ENGINEERING CHANGE NOTICE NO. 02621

DWG NO. 41228-202-020

DWG TITLE: GASKET

REASON: REVISED MATERIAL AND ADDED NOTE FOR MATERIAL SPECIFICATION

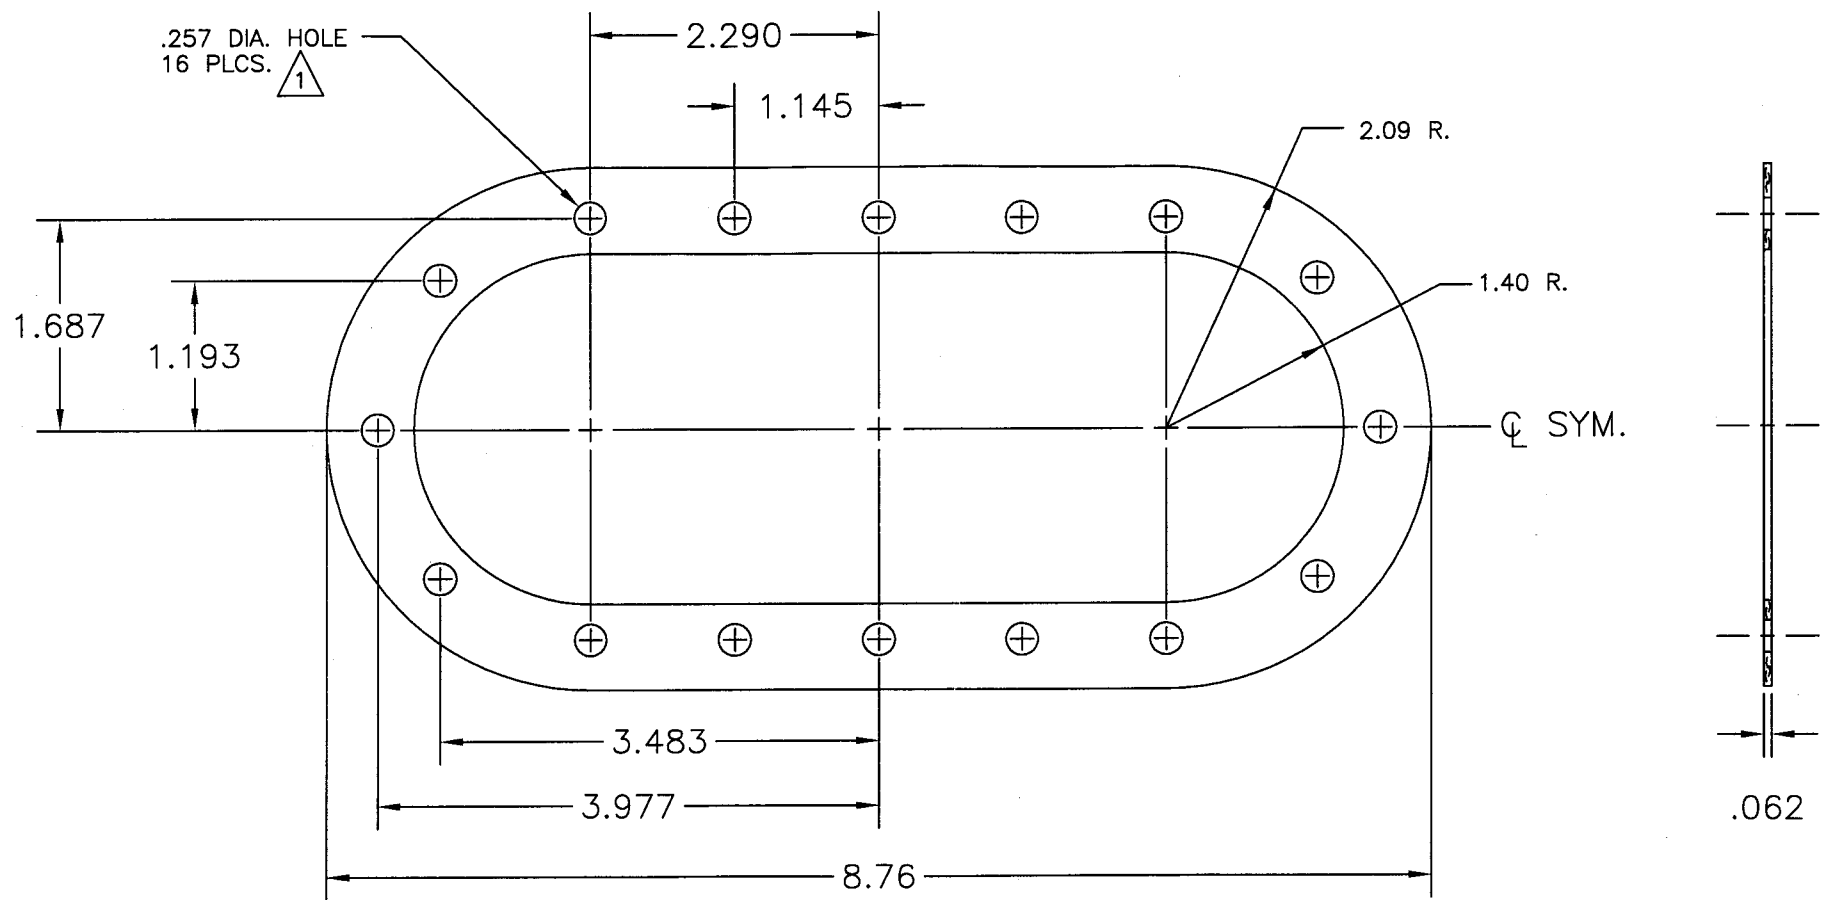
SHEET 1, NOTES, ADDED NOTE 2:

△
2 MATERIAL: BUNA-N CORK BLEND
APICAL P/N: 600.0044
VENDOR: McMASTER-CARR
VENDOR P/N: 96165K53
MEETS SAE-AMS-C-6183 SPEC

-	R	41228-202-020-001			GASKET	9.0X2.25X.062	CORK	△ 2	
			-001						
F/N	TC	PART NUMBER	QTY	NAME	STOCK SIZE	MATERIAL	MATL.SPEC	ZONE	
DOCUMENTS EFFECTED:					CHANGE CATEGORY		DER REVIEW REQUIRED		
					<input type="checkbox"/> MDL <input type="checkbox"/> INSTALL INSTRUC <input type="checkbox"/> ICA <input checked="" type="checkbox"/> BOM		<input type="checkbox"/> MAJOR <input checked="" type="checkbox"/> MINOR		
							<input type="checkbox"/> YES <input checked="" type="checkbox"/> NO
